**Proposal for amendments to the 04 series of amendments to  
UN Regulation No. 41 proposal, submitted by IMMA to the  
72<sup>nd</sup> GRBP session (document  
ECE/TRANS/WP.29/GRBP/2020/18)**

**UN Regulation No. 41 (Noise emissions of motorcycles)****Proposal for amendments to the 04 series of amendments to  
UN Regulation No. 41****Submitted by the experts from the International Motorcycle  
Manufacturers Association\***

The text reproduced below was prepared by the expert from the International Motorcycle Manufacturers Association (IMMA), in order to align the 04 series of amendments to UN Regulation No. 41 with standard ISO10844:2014. It is based upon UN Regulation No. 41 up to Supplement 7. The modifications to the Regulation are marked in bold for new or strikethrough for deleted characters.

Figure 1  
**Test track layout with dimensions in meters**

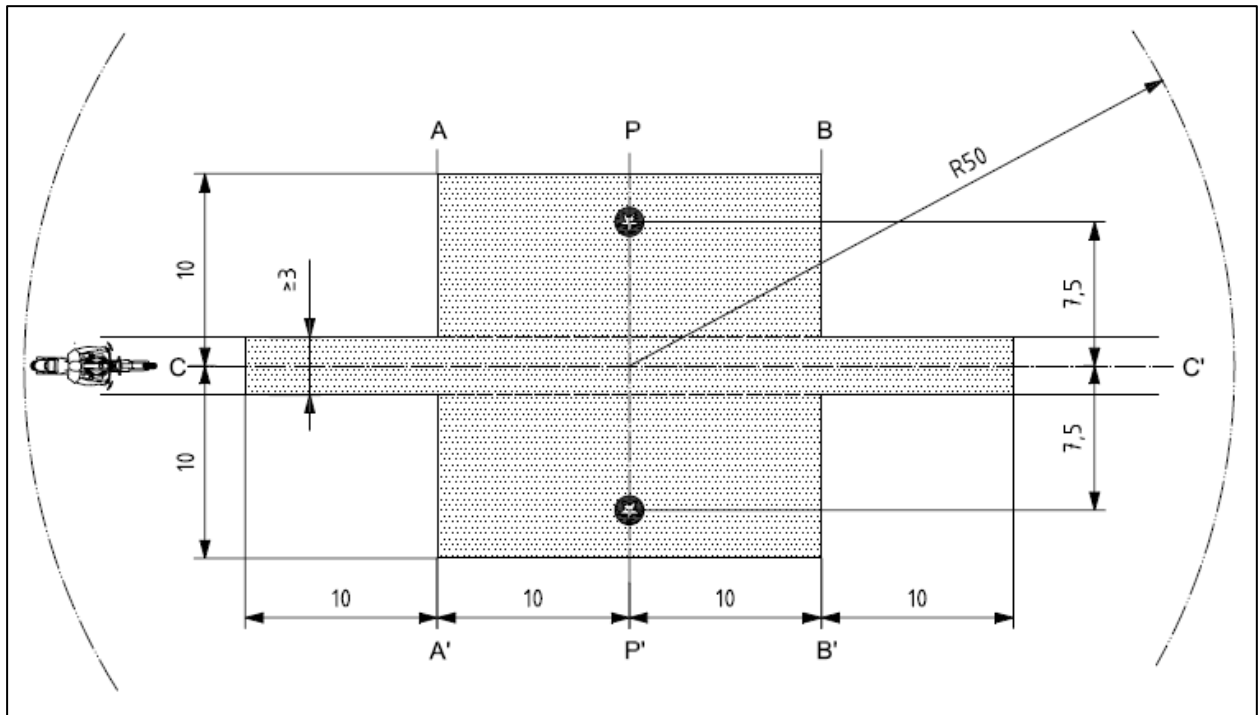
*Figure 1*, amend to read:

4. IMMA would like to replace the current Figure 1 of Annex 4 with the one in higher resolution.
